Access Compliance Report

Public Rights-of-Way

(Curb Ramps)

Intersection ID: 12519	Main Street: E_6TH_ST	Cross Street: N_CALDWELL_ST	Location: S
ADA ID: 8D3810AEE38D	Ramp Type: BlendTrans1	Initial Pass/Fail: Fail	Overall Compliance: No
		Severity Score: 10

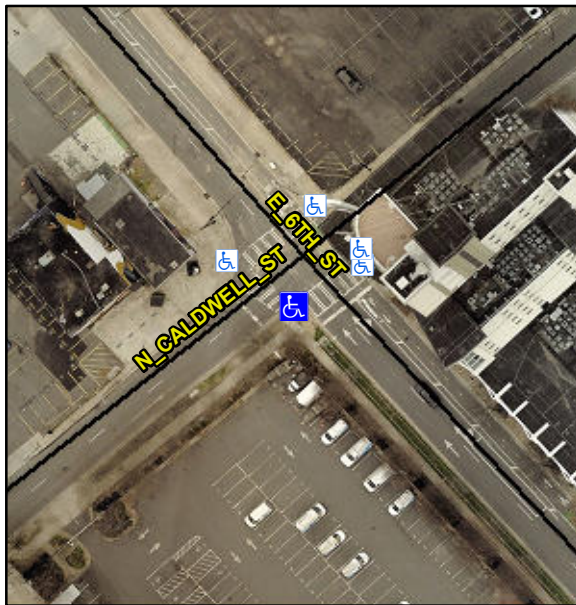
Not Found, R304.5.1, R304.5.3

Compliance	Description	Data	Compliance	Description	Data
N/A	Ramp Length (in)	75.0	Yes	BlendTrans Slope (%)	0.8
No	Ramp Width (in)	47.0	No	BlendTrans XSlope (%)	5.0
N/A	Flare Type LT	N/A	N/A	Flare Type RT	N/A
N/A	Flare Slope LT (%)	N/A	N/A	Flare Slope RT (%)	N/A
N/A	Flare Traversable LT?	N/A	N/A	Flare Traversable RT?	N/A
N/A	Landing Length (in)	N/A	N/A	DWS Provided?	N/A
N/A	Landing Width (in)	N/A	N/A	DWS Contrast?	N/A
N/A	Landing Slope (%)	N/A	N/A	DWS Length (in)	N/A
N/A	Landing X Slope (%)	N/A	N/A	DWS Full Width?	N/A
N/A	Landing Curb? (Y/N)	N/A	N/A	DWS Offset (in)	N/A
N/A	Shared Landing?	N/A			
N/A	Gutter Ponding?	Yes	N/A	Gutter Slope (%)	N/A
N/A	Gutter Lip Ht (in)	2.0	N/A	Gutter X Slope (%)	N/A
N/A	Painted X Walk1?	Yes	N/A	Painted X Walk2?	Yes
	X Walk 1 Direction	To NE		X Walk 2 Direction	To NW
	X Walk 1 Width (in)	102.5		X Walk 2 Width (in)	101.5
	X Walk 1 Slope (%)	0.5		X Walk 2 Slope (%)	4.0
	X Walk 1 X Slope (%)	6.2		X Walk 2 X Slope (%)	0.3

N/A	Ramp inside XWalk1?	Yes	N/A	Ramp inside XWalk2?	Yes
	Road Slope (%)	1.1		Clear Space?	N/A
	Road X Slope (%)	4.2	N/A	Clear Space to XWalk (in)	N/A
N/A	Any Obstructions?	N/A	N/A	Storm Grate/Utility Hazard?	N/A
	Obstruction Type			Storm Grate/Utility Type	
		N/A			N/A
			Yes	Surface Condition? (G/P)	Good
			No	Curb Slope (%)	16.0

Remove & Replace Curb Ramp With Two New Directional Ramps or Equivalent.
